Subj: VF-124 AAR ser 7-61 concerning F8U-2 BuNo 146982, accident occurring
9 September 1961, pilot (b) (6)

FIFTH ENDORSEMENT on FITRON 124 AAR ser 7-61 concerning F8U-2 BUNO
146982 accident occurring 9 September 1961 pilot (b) (6)

FOURTH ENDORSEMENT on FITRON 124 AAR ser 7-61 concerning F8U-2 BUNO
146982 accident occurring 9 September 1961 pilot (b) (6)

SECOND ENDORSEMENT on VF-124 AAR 7-61 concerning F8U-2 BuNo 146982
occurring 9 SEP 1961, Pilot (b) (6)

WING SPREAD SEQUENCE VALVE

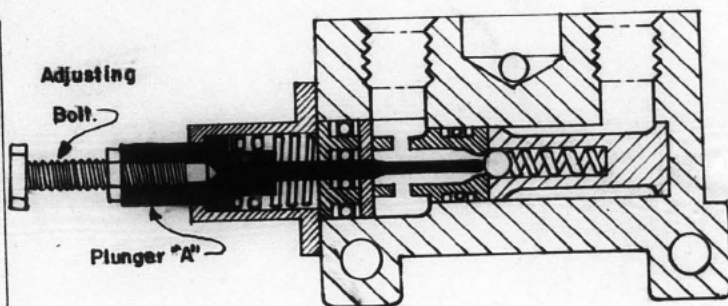
An investigation was conducted on the operation of the sequence valves of two different aircraft on the VF-124 line. Referring to enclosure (10), it can be seen that during the spread sequence, plunger "A" has to be depressed by striker plate "B", unseating the spring loaded ball check valve, before fluid can flow to the wing hinge pin actuating cylinders. Tests showed that after the completion of step (e) of the rigging instructions listed above, between $\frac{1}{4}$ and $\frac{3}{4}$ turn-in of the adjusting bolt would allow the wing hinge pins to go only partially home. To be more specific, the pins extended approximately three inches each, progressing only through one forward and one aft lug on the outer wing panel. Further test showed that the difference in displacement of plunger "A" required for complete operation and partial operation of the wing hinge pins resulted from $\frac{1}{3}$ to $\frac{1}{2}$ turn of the adjusting bolt. One half turn of the adjusting bolt is equal to .0178 inches. As stated in step (f) of the rigging instructions listed above, one more full turn-out (.0357 inches) is required for correct rigging. In other words, the approximate overall displacement for proper rigging would be .0535 inches as a minimum, from the time the ball is displaced by plunger "A".

If the system possessed overall mechanical rigidity, this tolerance would not be of particular concern. However, such is not the case. There are factors present in the system which tend to reduce the tolerance merely as the result of normal operation. An elongated, concave depression develops in the outer wing panel striker plate as the result of contact with the adjusting bolt during repeated folding and spreading of the wings. The average striker plate depression on VF-124 F8U-2 aircraft was found to be .012 inches. In addition, the striker plates are painted surfaces, and if the sequence valve is rigged with the paint still present, subsequent wearing off of the paint further reduces the displacement of the sequence valve plunger.

When the spring loaded ball check valve is unseated, hydraulic pressure acts against the internal surface area of the plunger attempting to force the plunger out. This force is transmitted to the striker plate and its support panel which "oil cans" or gives way. This "oil canning" movement is very noticeable in the opposite direction when sequence valve internal hydraulic pressure is relieved by selecting the wings folded position in the cockpit. With sufficient misrigging of the adjusting bolt this mechanical give in the system causes the spring loaded ball check valve to re-seat, stopping the flow of hydraulic fluid to the wing hinge pin actuators. The re-seating of the ball is evidenced by a noticeable chattering noise. With a hydraulic pressure gauge installed between the sequence valve and the wing hinge pin actuators, a rapid pressure fluctuation was observed while the chattering noise was evident, followed by a drop to 0 pressure as hinge pin movement, and the chattering noise, ceased.

a. Paragraph 1179, subparagraph (e.) With hydraulic power on, turn adjusting bolt out until it contacts outer wing panel bracket and wing hinge pin extends fully. Check extension as per FIG 1114 steps 24 and 25.

b. Paragraph 1179, subparagraph (f.) Turn adjusting bolt out TWO full turns, tighten and safety locknut. NOTE: Insure that sequence valve plunger does not rotate while adjusting bolt is turned.

2. The locknut on the adjusting bolt of the wing spread sequence valve be modified to permit effective safety wiring to the plunger.

VF-124 AAR 7-61 18 BUNO 146982
VIEW OF AFT LOCKING CYLINDER AND LUGS (WING PANEL) (INTACT LUGS ON WING PANEL)
SPECIAL HANDLING REQ. IN ACCORDANCE WITH OPNAV INST. 3750.6D PARA 70 ENCL. (97)

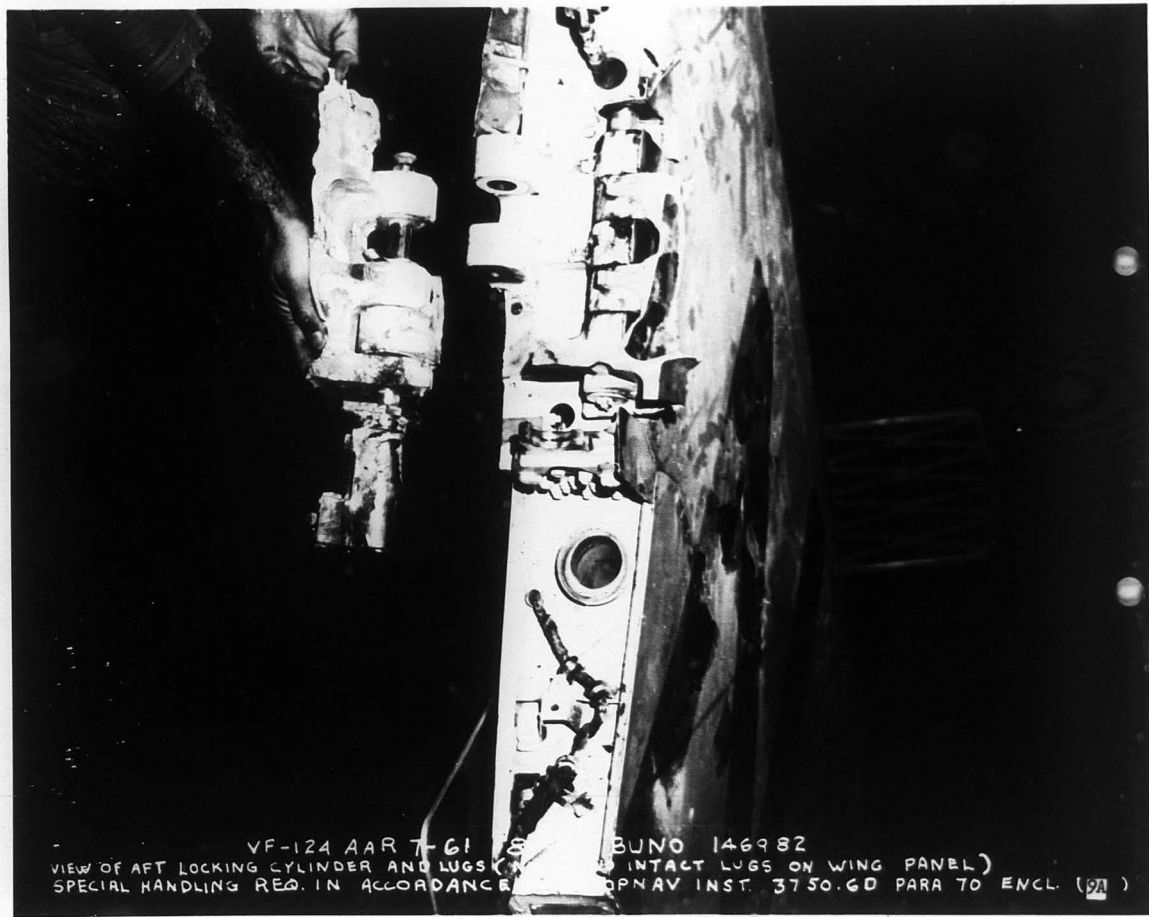
(1) Starboard aft, wing hinge pulling cylinder assembly, with a portion of the starboard center section rib assembly attached. (See enclosure (9c)). See enclosure (9A) which shows the assembly in relation to the matching portion of the starboard outer wing panel rib assembly.

Of particular interest was the starboard outer wing panel hinge area. When the two hinge pin pulling cylinder assemblies recovered from the impact area were mated to their appropriate positions on the outer panel, it was obvious that the wing hinge pins were extended only through the first outer panel lug in each case. (See enclosures (9A) & (9B)). Impact forces upon aircraft contact with the ground is the only logical explanation for the additional travel of the hinge pins.

VF-124 AAR 7-61 F8U-2 BUNO 146982
VIEW OF 'FWD' LOCKING CYLINDER AND LUGS (NOTE ONE LUG IS STILL INTACT)
SPECIAL HANDLING REQ. IN ACCORDANCE WITH OPNAV INST. 3750.60 PARA 70 ENCL. (9B)

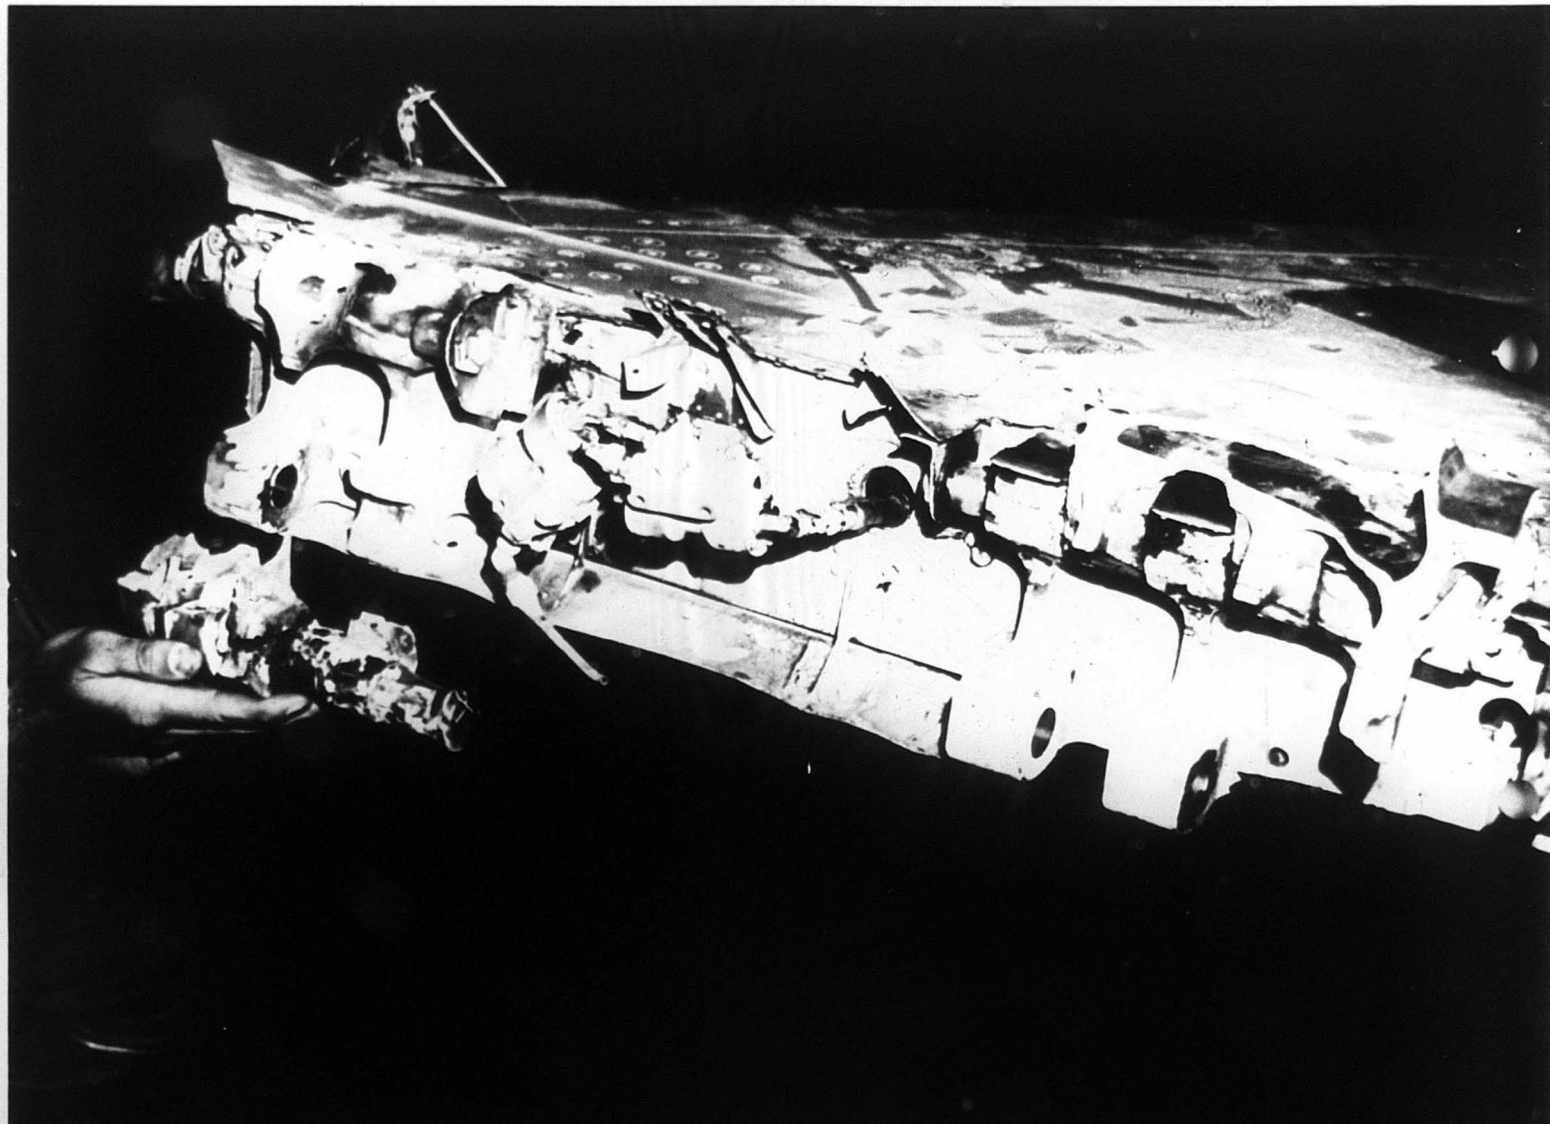
(2) Starboard forward wing hinge pulling assembly with a portion of the starboard center section rib assembly attached. See enclosure (9B), which shows this assembly in relation to the matching portion of the starboard outer wing panel rib assembly.
